File RP-1996-137

Name: Cimarron Minor Subdivision - 24 1/2 Road / F Road - Replat

# REVIEW COMMENTS

FILE #RP-96-137

DRAINAGE PLAN  
40 SCALE

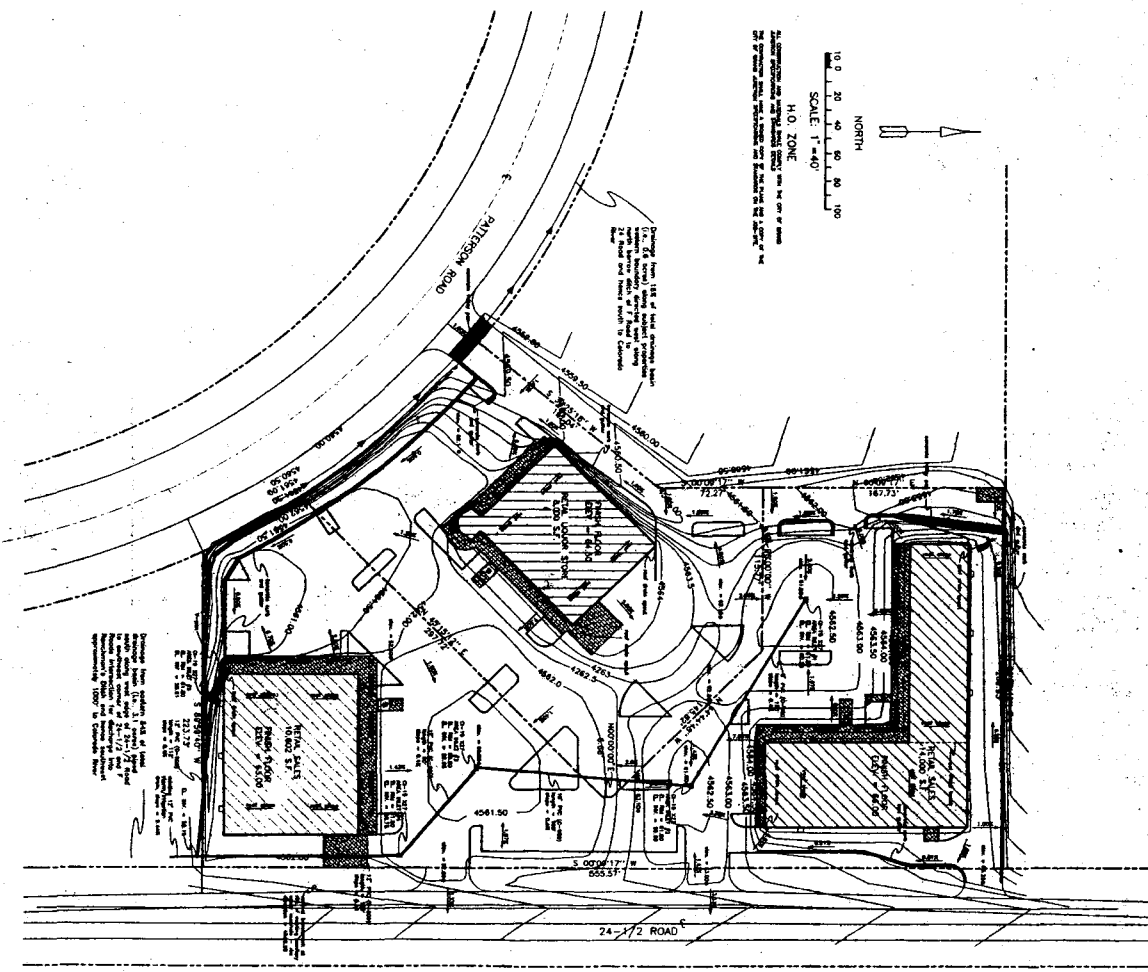
The drainage plan does recognize that there have been changes in the surface water flow patterns compared to approximately 20 years ago. The statement about the borrow ditch along the north side of F Road and the flows to the west to the channel of Leach Creek is accurate, however, the route of the surface water and the point where that water enters Leach Creek are generally not maintained by anyone. The District does not have the authority to require private parties to maintain their waste ditches. It would seem that the City, as part of a review and approval process does have the authority to see that a downstream property is not injured by waters from an upstream property. Maintenance of a borrow ditches is necessary. The City may have the right to require such maintenance or at least require the developer to show who the maintaining party will be and how the ditch will be operated.

**SITE PLAN**

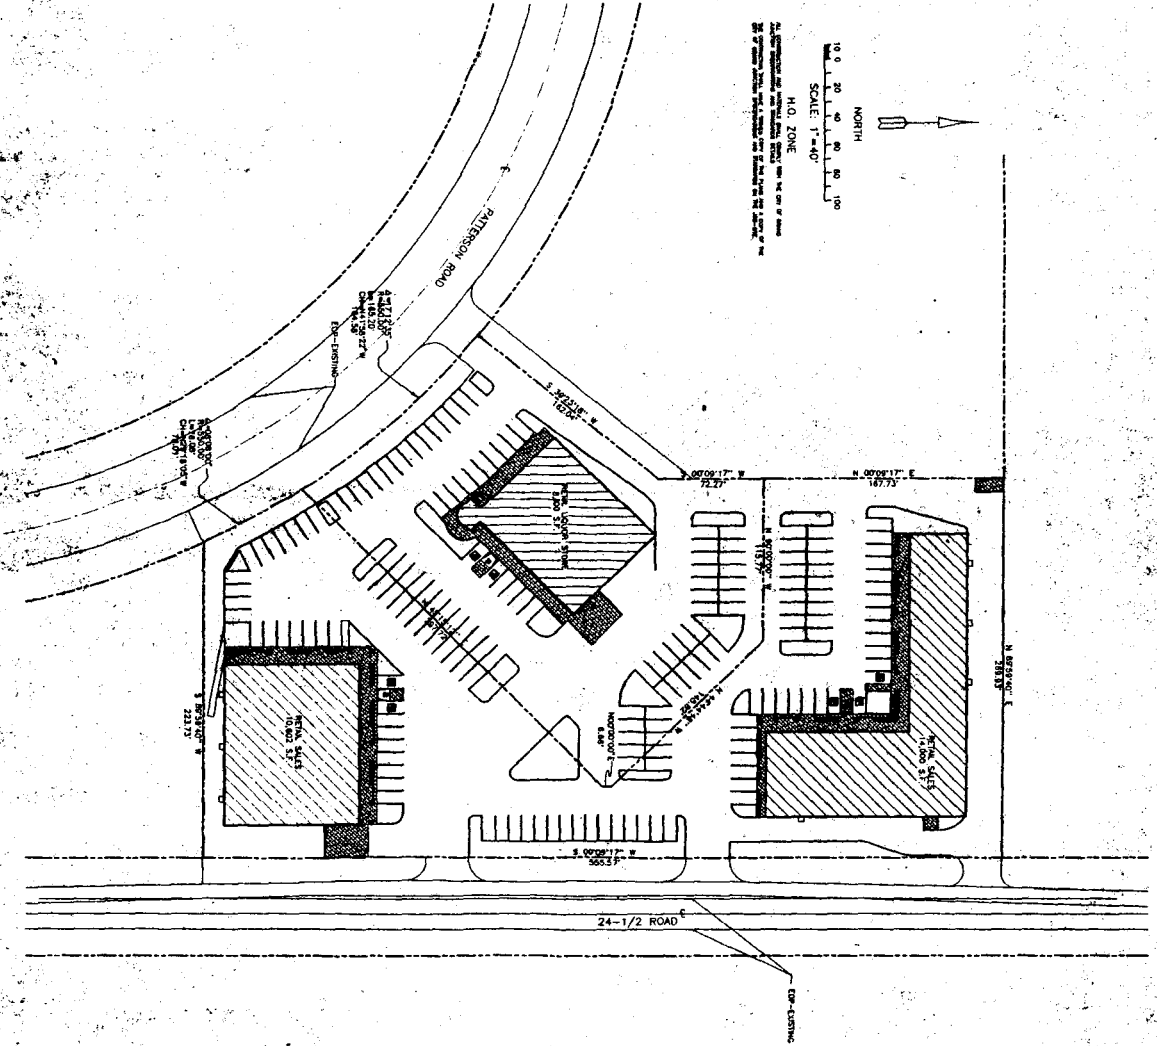
SITE/PARKING/LIGHTING/LANDSCAPE PLANS

1. Covered walk on 2 sides of liquor store shown as brick walk? Footprint of entry area does not seem to match how it is portrayed on the floor plans.
2. Please verify parking numbers--plan seems to show 179 vehicle spaces, but table indicates 186 (both counts including accessible spaces).

3. Minimum parking stall dimension is 9' x 18.5' (rather than 18' noted on plan).
4. The pole sign shown along 24-1/2 Road for the liquor store is not allowed. This would be considered an off-premise sign which are not allowed in the H.O. zone. A pole sign in this location for the two retail buildings is acceptable.

5. Adjust locations of lights to eliminate dark spots (see attached red-lined drawing).
6. Are planters shown on floor plan of retail centers #1 and #2 supposed to be the same landscape areas as those shown on landscape plan? If so, they don't match.

**Comment** 1. Covered walk on 2 sides of liquor store shown as brick walk? Footprint of entry area does not seem to match how it is portrayed on the floor plans.

**Comment** 2. Please verify parking numbers - plan seems to show 179 spaces, but the table indicates 186 (both counts including accessible spaces).

**Comment** 3. Minimum parking stall dimension is 9' x 18.5' (rather than 18' as noted on the plan.

**Comment** 4. The pole sign shown along 24 ½ road for the liquor store is not allowed. This would be considered an off premise sign which are not allowed in the H.O. zone. A pole sign in this location for the two retail buildings is acceptable.

**Comment** 5. Adjust locations of lights to eliminate dark spots (see attached red-lined drawing).

**Comment** 6. Are planters shown on floor plans of retail centers #1 and #2 supposed to be the same landscape areas as those shown on the landscape plan? If so they don't match.

Site Plan - Comments addressed, however, please note that the labels are reversed in the legend.

**Response:** The covered walk is going to be concrete and a symbol has been added to the legend indicating that the hatch pattern represents concrete. The footprint of the entry area has been changed to match the floor plans.

**Response:** The parking space count is 179 including accessible spaces, but not including bicycle parking. The parking space calculation table has been changed to reflect the true number of spaces on the plan.

**Response:** The notation on the plan has been changed, the spaces are dimensioned correctly.

**Response:** The sign will be changed to show that it is for the retail buildings.

**Response:** The so-called "dark spots" are not really dark spots. Light is subject to the theory of inverse square law, thus the intensity of light is inversely proportional to the square of the distance from the source. This principle is used to derive the isofootcandle chart on the plan. Additionally, light as a wave energy source is subject to the law of superposition. Thus, the intensity at a location is additive. Application of these natural laws to the problem at hand results in a finding that the light intensity in the "dark spot" where the 4 lights radiuses converge in the parking area, actually exceeds the required .6 lumens and is approximately 1.8 lumens within the "dark spot". Similarly for the "dark spot" in the southwest part of the liquor store parking area, the actual lighting intensity from adding the intensity of the two converging light sources is approximately .8 lumens. Despite these findings, the light on the east side of the liquor store has been moved east approximately 10 ft and is now a pole light located within a landscaped area. This move was made because the light would have been above the covered walk way and would have created a shadow in the parking on the east side of the liquor store. Moving this light eliminates one "dark spot" and the shadow. The other lights have not been moved.

**Response:** Planter layout has been changed to be consistent between the floor plans and the landscape plan.
